**MODEL 211.0 /2 /6
as of model year 04**

Modification notes

P46.10-2627-06

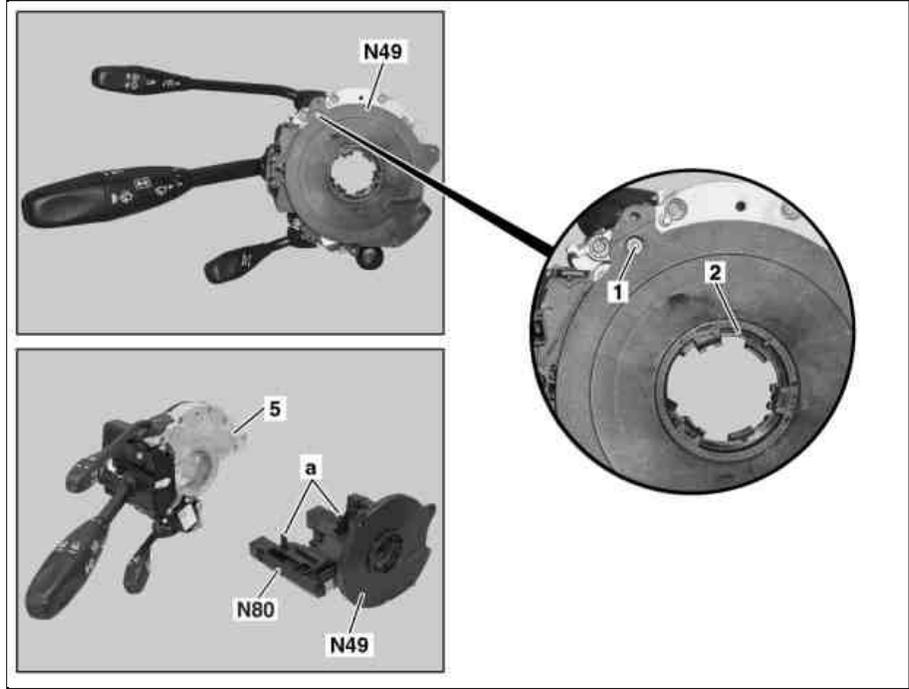
25.11.08	Perform initialization of DTR control unit after replacing steering angle sensor, added	Step 6	
----------	---	--------	--

5	Install in the reverse order		
6	Perform initialization of DTR control unit with STAR DIAGNOSIS	After replacing steering angle sensor (N49) on vehicles with code (219) Distronic (DTR)
